Subject: Meritor WABCO OnGuard System

Models Affected: Specific Freightliner Cascadia vehicles manufactured November 13, 2012, through March 13, 2014, with a Meritor WABCO OnGuard system.

Daimler Trucks North America LLC, on behalf of its Freightliner Trucks Division, is initiating Field Service Campaign SF499A-H to modify the vehicles mentioned above.

June 2014
SF499A-H

Fig. 9, OnGuard Harness Routed Under the Forward Crossmember

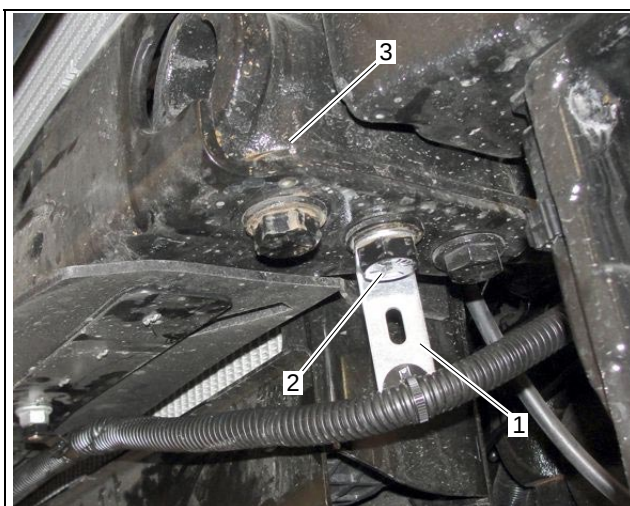
1. Remove the bumper.
2. Locate the radiator air baffle on the driver's side of the vehicle, and remove the two mounting bolts nearest to the OnGuard mounting bracket. See **Fig. 9**. Flip the orientation of the bolts and install them so that the threads are facing down. Tighten the nuts securely.
3. Position a stud-mount tie strap (23-12115-001) on each bolt thread, then secure the harness. See **Fig. 9**.
4. Install the L-bracket.
 - 4.1 Remove the center mounting bolt from the driver's-side frame rail extension. See **Fig. 10**.
 - 4.2 Position the L-bracket (23-09130-007) on the frame rail extension at a 45° angle so that the "L" is facing away from the vehicle, then install the bolt.

A. The stud-mounted tie straps attach to the threads of the air baffle bolts.

Fig. 11, Excess Harness

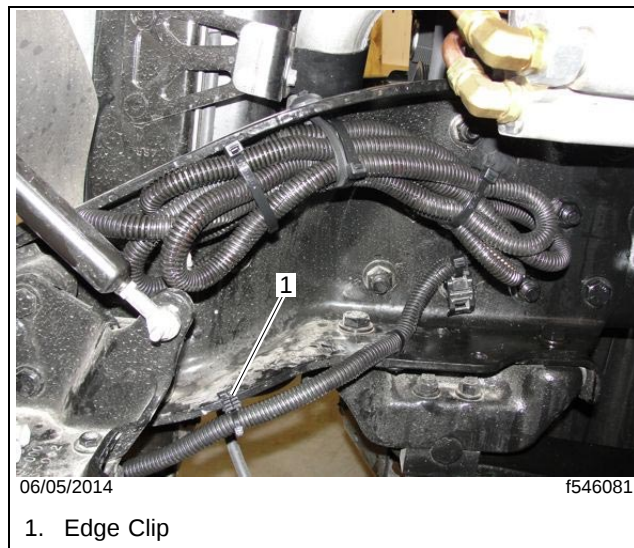
NOTE: Use an edge clip (23-13477-200), if necessary, to keep the harness away from the frame rail extension. See **Fig. 11**.

5. Bundle any excess harness in the engine bay, and tuck it tightly against the frame rail. Secure the harness with button-head tie straps (23-12069-001) so that it does not come in contact with the steering column or any other moving parts. See **Fig. 11**.
